**PLANNED UNIT DEVELOPMENT
& SUBDIVISION STAFF REPORT**

Falling Leaf Subdivision

Planned Unit Development Approval to allow a gated private street single-family residential subdivision.

SITE PLAN

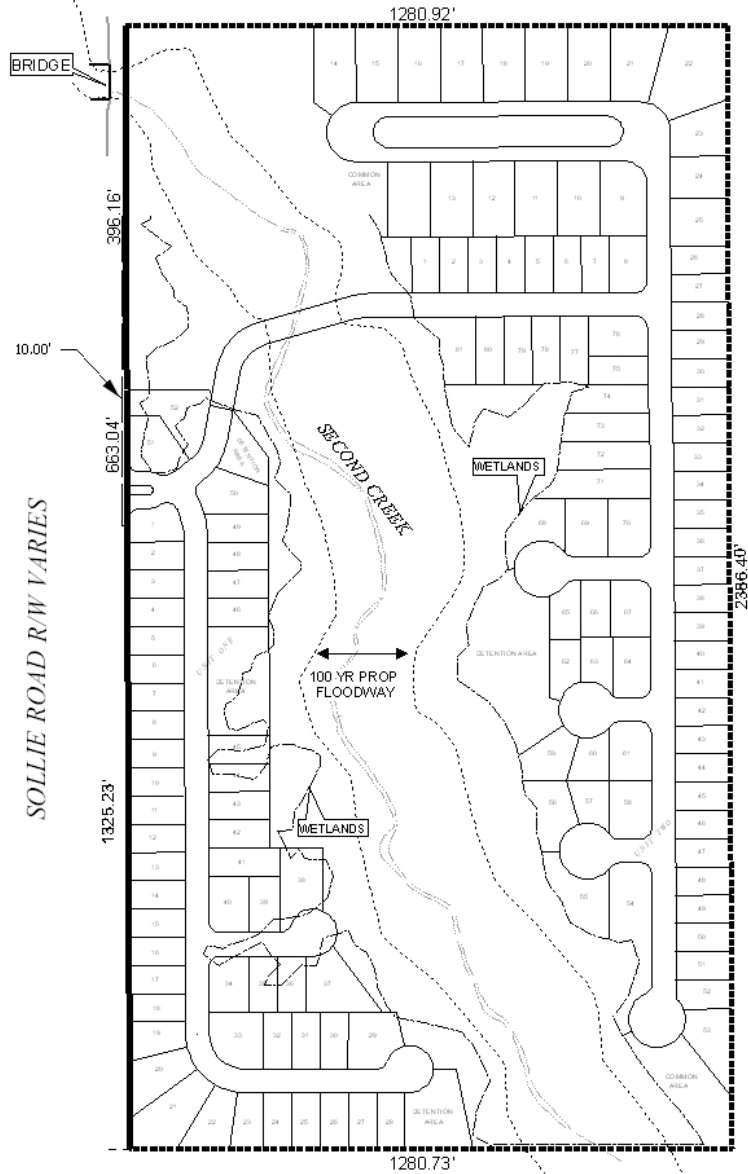
Additionally, since Lots 8, 9, 56, 60, 61, 66, 67, 73, and 79 are corner lots, a note should be placed on the Final Plat stating they are limited to one curb-cut each with the size, design and located to be determined by Traffic Engineering. Labeling of each lot with its size in square feet, or provision of a table on the plat with the same information is also requested.

The site is bisected by wetlands and is illustrated as a floodway (Second Creek) on the preliminary plat. The presence of wetlands indicate that the area may be environmentally sensitive; therefore, the approval of all applicable federal, state and local agencies would be required prior to the issuance of any permits or land disturbance activities.

It appears that each lot meets the minimum size requirements for developments with access to public water and sewer. Due to the size of the proposed development, it is requested that the applicant revise the preliminary plat to provide the size of each lot in square feet on the plat, either as a table or as a label for each individual lot.

Several areas are shown on the preliminary plat along the Second Creek and between the one-way streets that should be labeled as common area, thus a note should be placed on the Final Plat stating that maintenance of the common area will be the responsibility of the property owners.

There is an apparent mislabeling of lots on the plat submitted and on the application form – both of which indicate the overall subdivision as containing 133 lots. Close review of the plat found a lot that was not numbered, and apparently was not accounted for on the application form. This misinformation has created an issue in that the required notices were inaccurate because they reflected information as indicated on the application form and plat.

Also, as the application makes no reference to decreased setbacks or increased site coverage, all requirements of the Zoning Ordinance would apply. Further, no information was provided on the plat indicating the location of the proposed gate.
